- .1 Cover Page – Addendum No.6 – 1 page;
 - .2 Civil Addendum C2 dated March 28, 2018 – 1 page;
 - .3 Architectural Addendum A4 dated March 28, 2018 – 20 pages including 9 drawings;

Architectural Addendum A4

PROJECT TITLE	East Hants Aquatic Centre
---------------	---------------------------

1 HEATING WATER SCHEMATIC

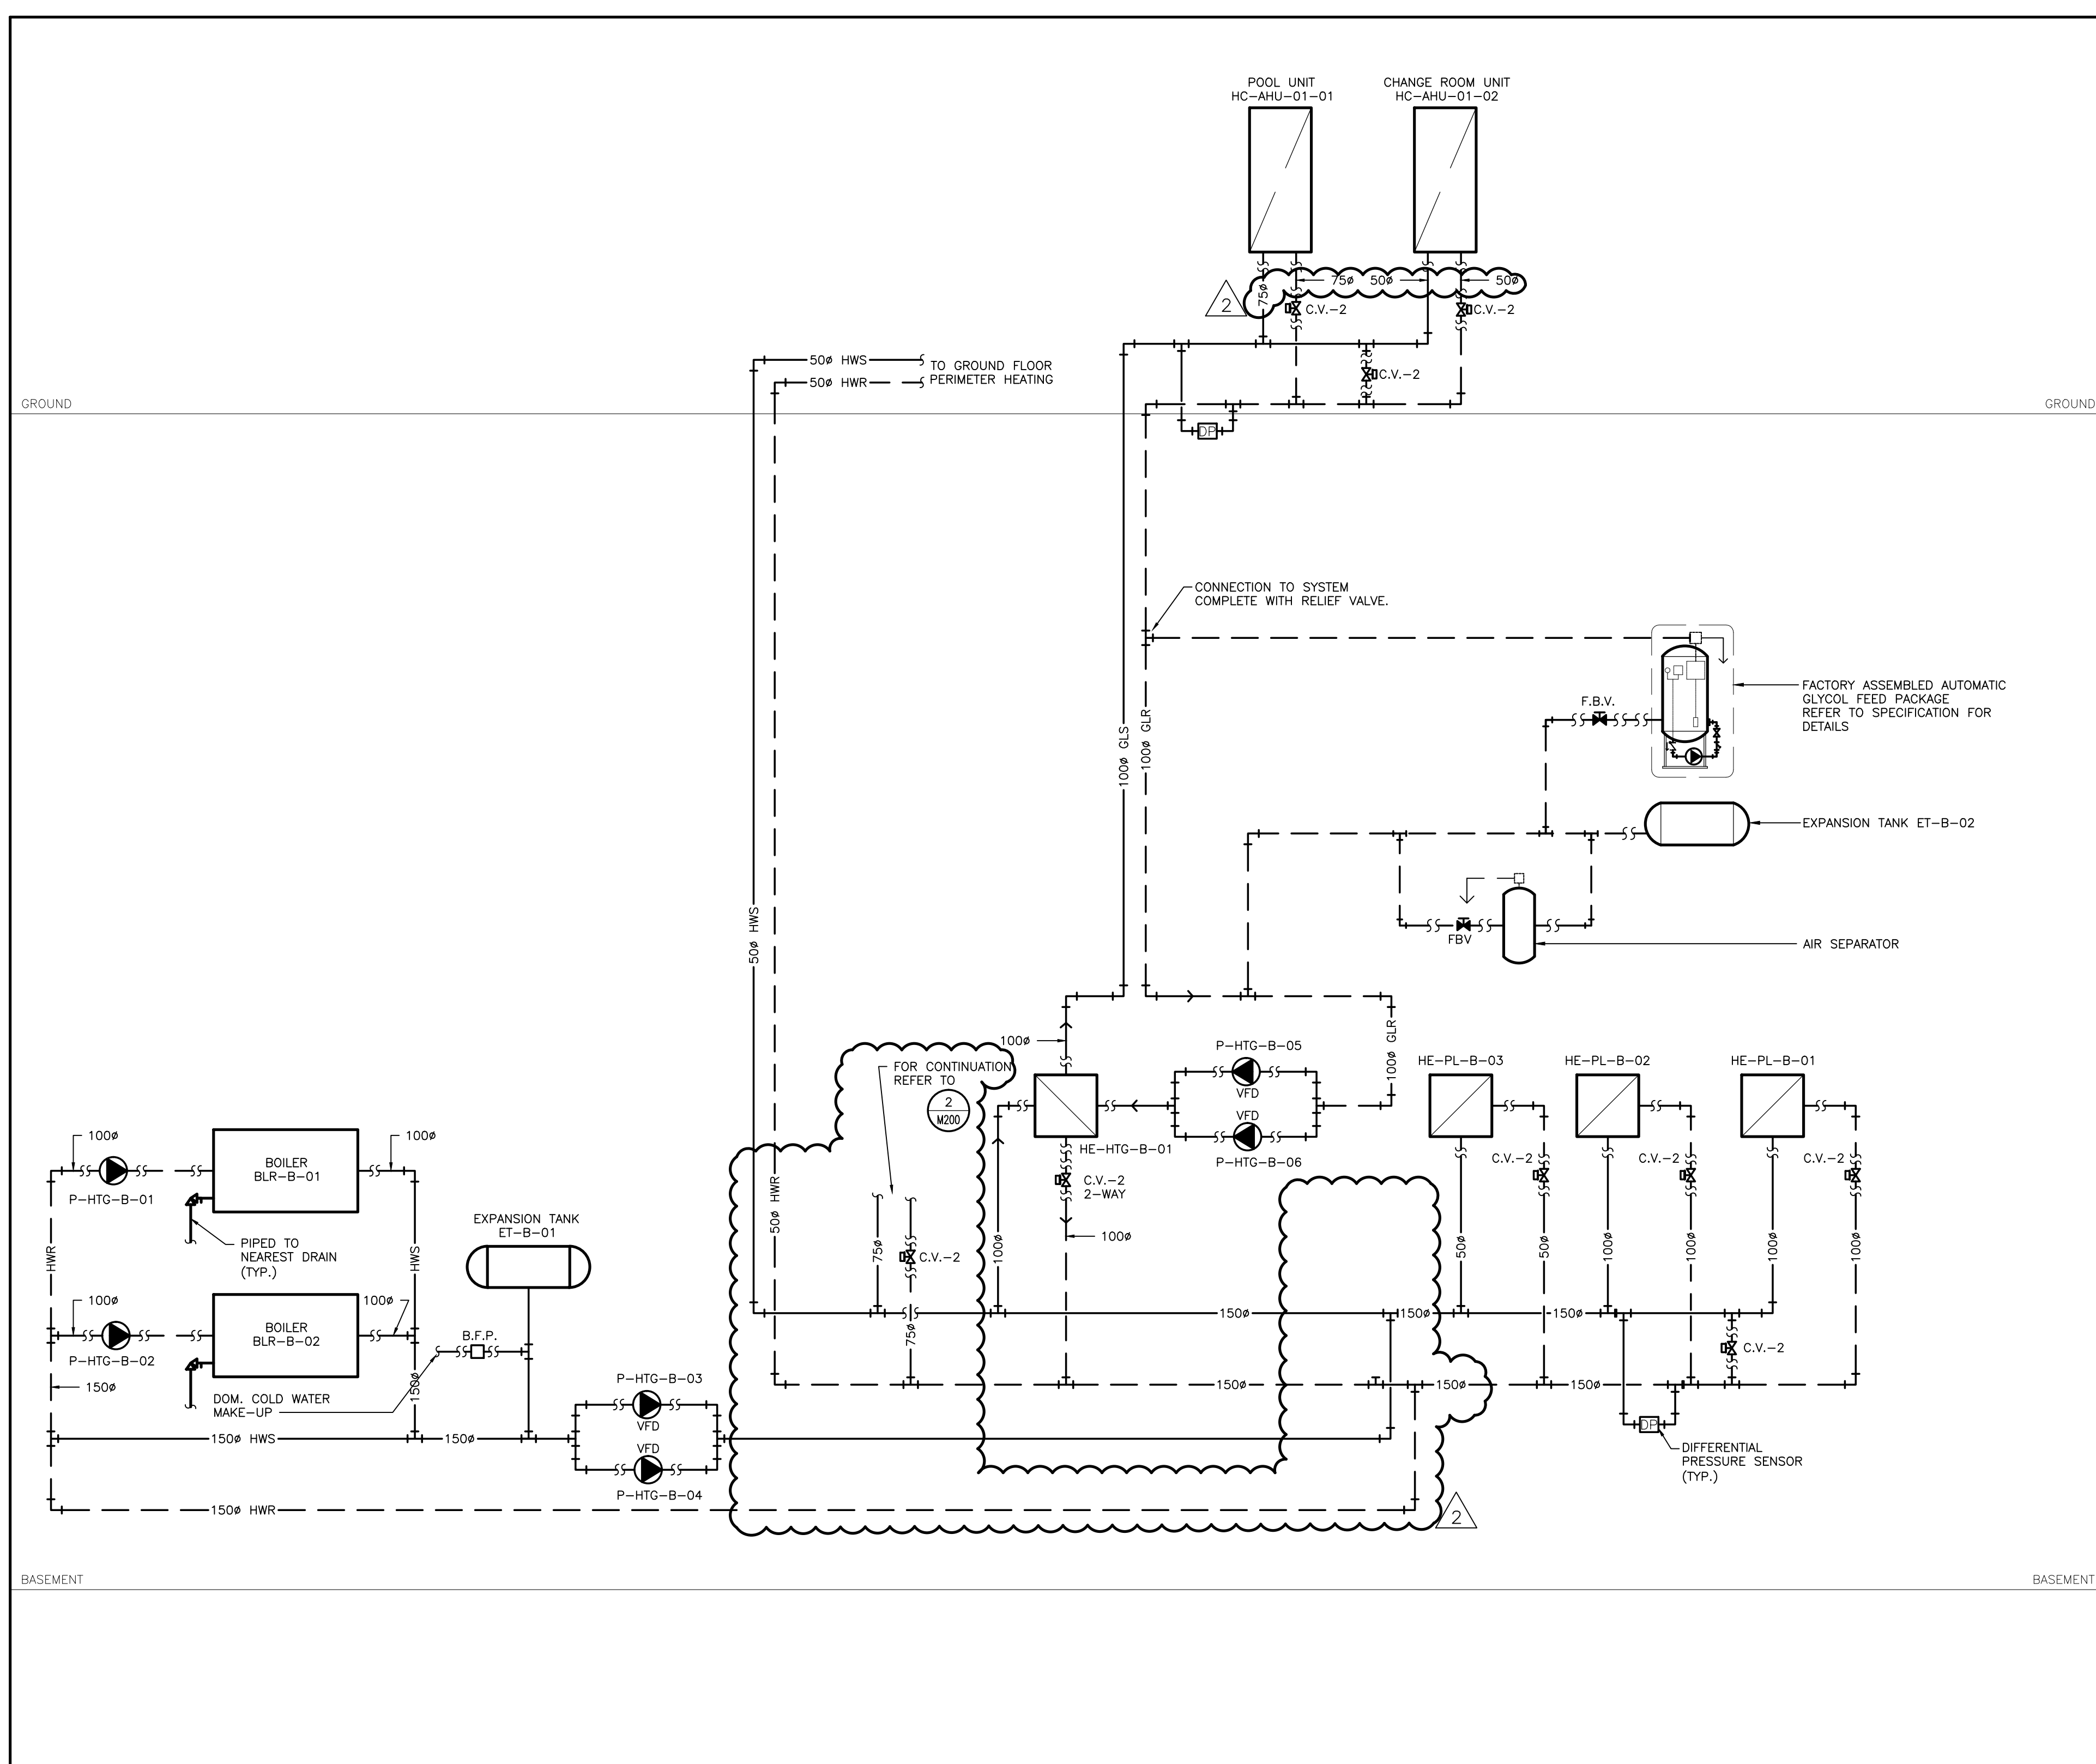
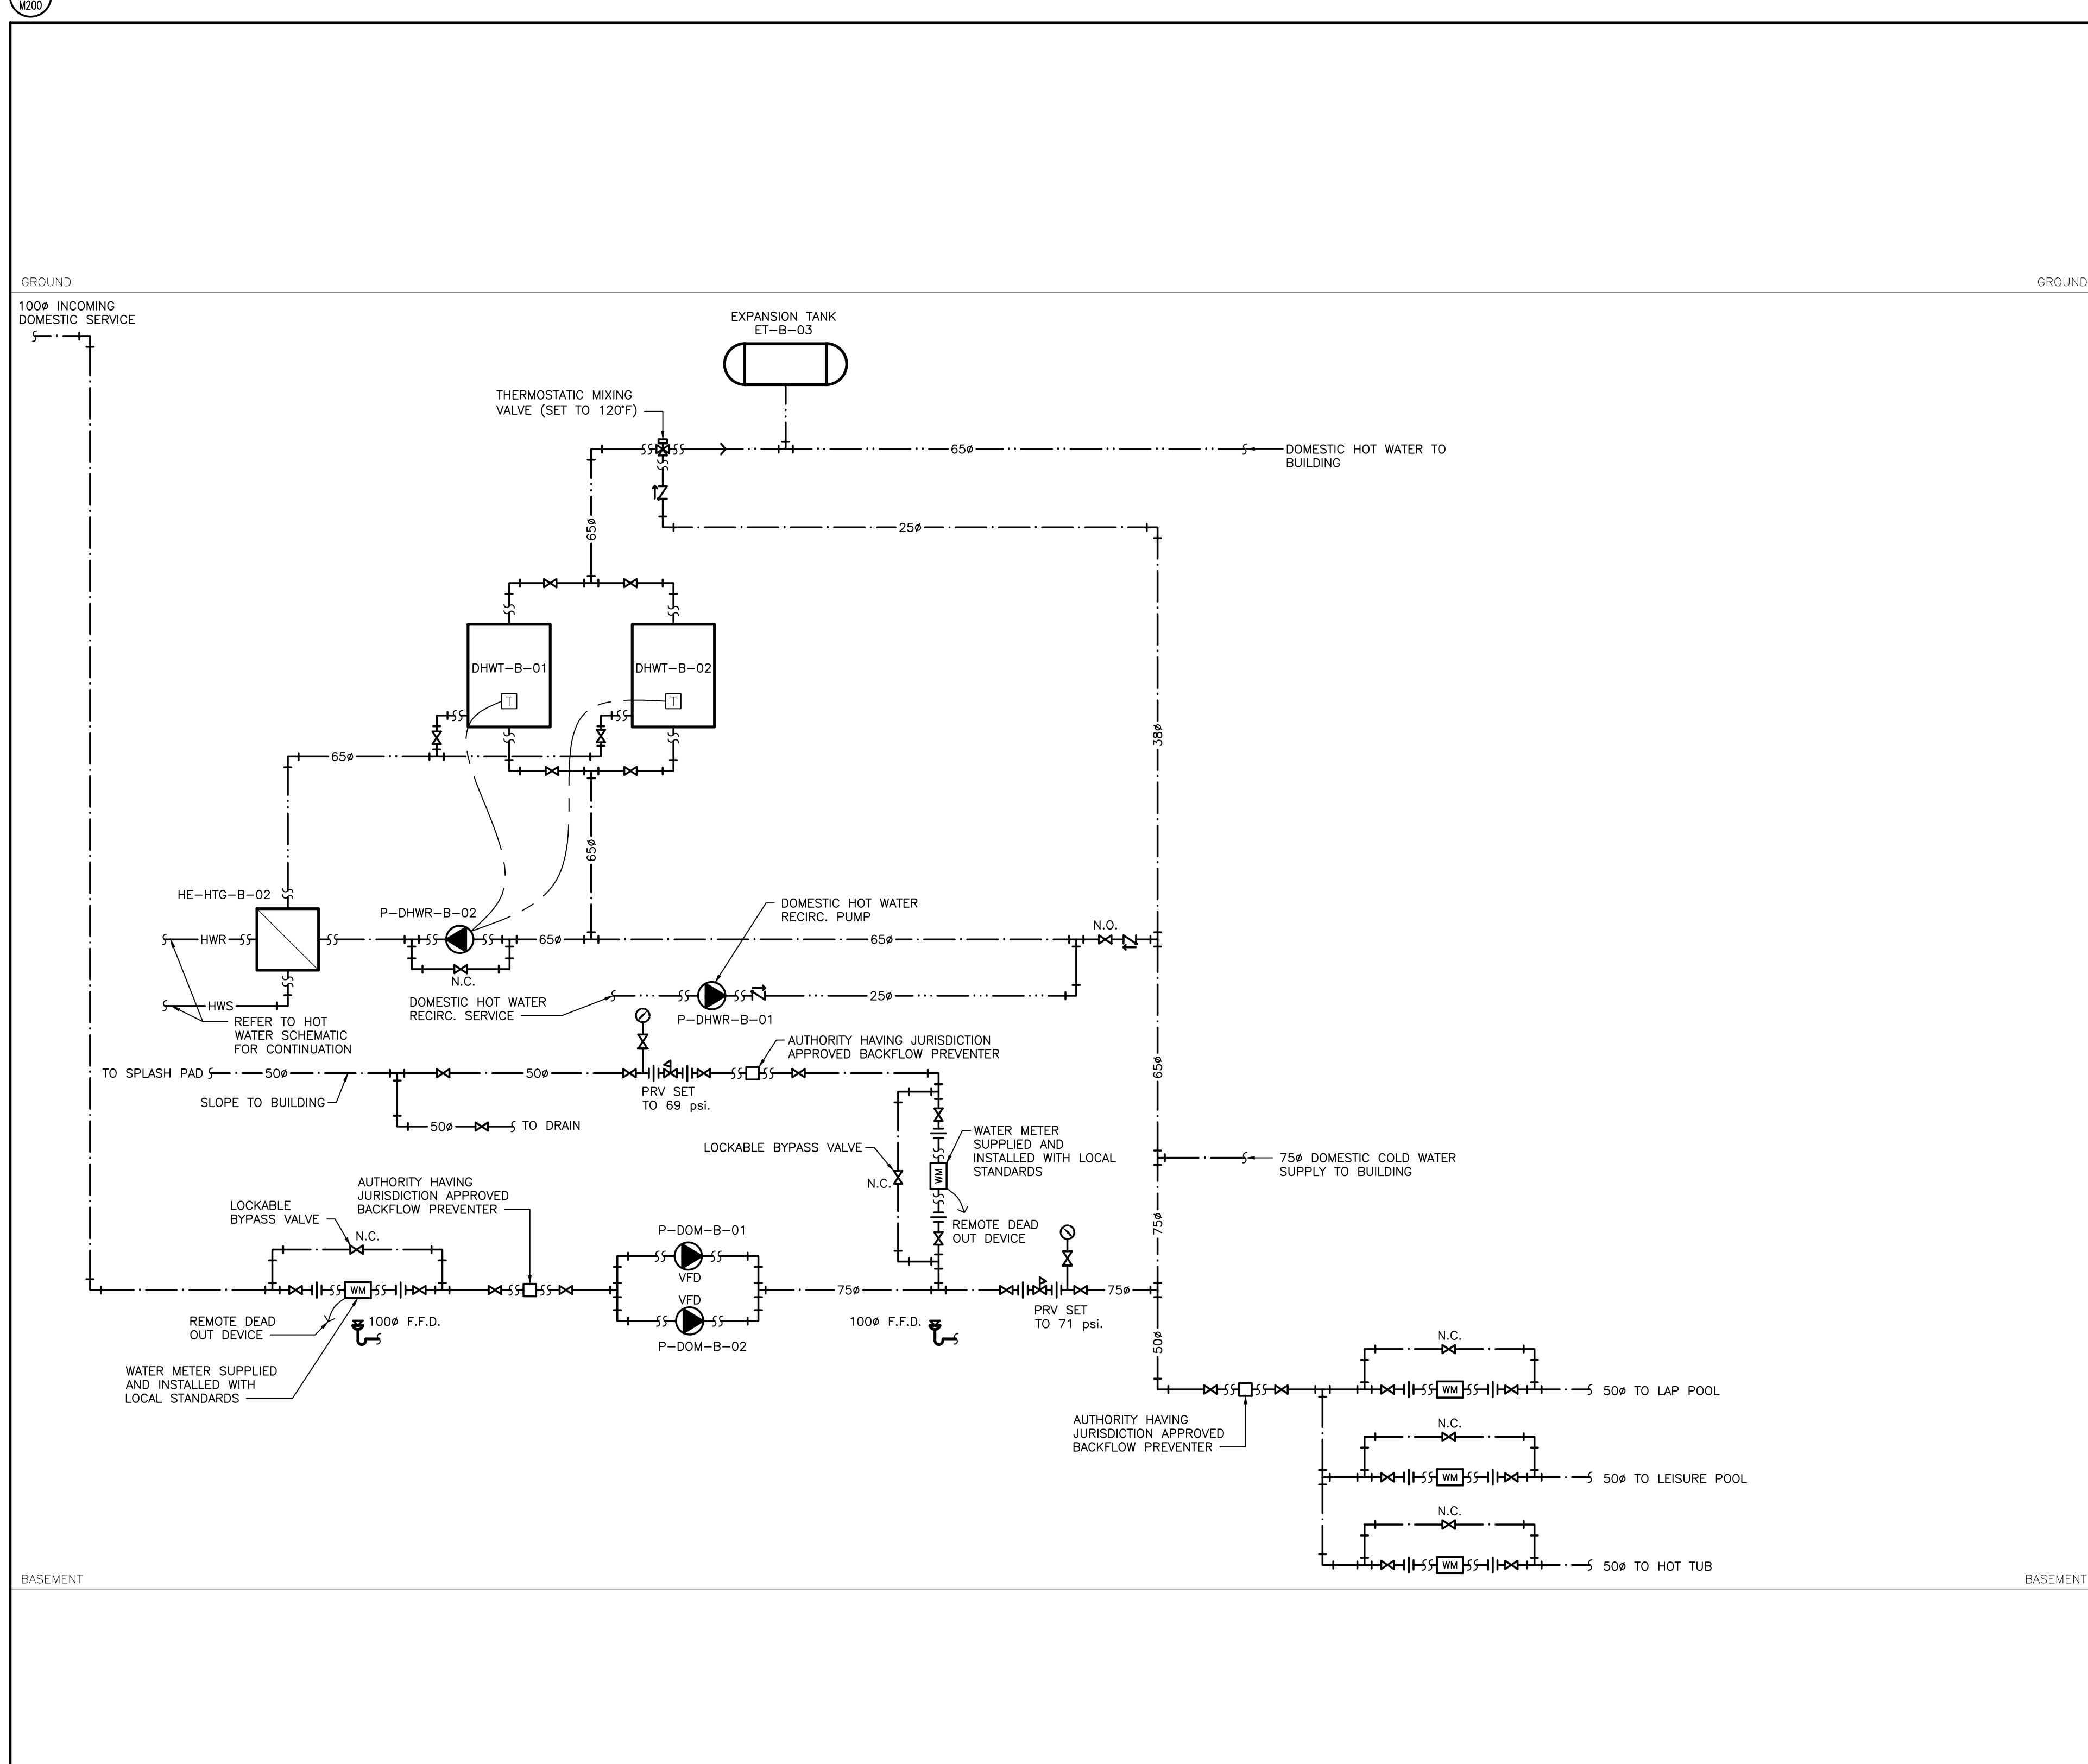
"Regarding drawing M600A on the lower left corner, the drawings indicate the exhaust pipe to be 3" in diameter. The exhaust pipe has a run of approximate 57ft and then up another 20ft. According to the engine manufacture 3"" will not be large enough. Please confirm pipe size diameter. "
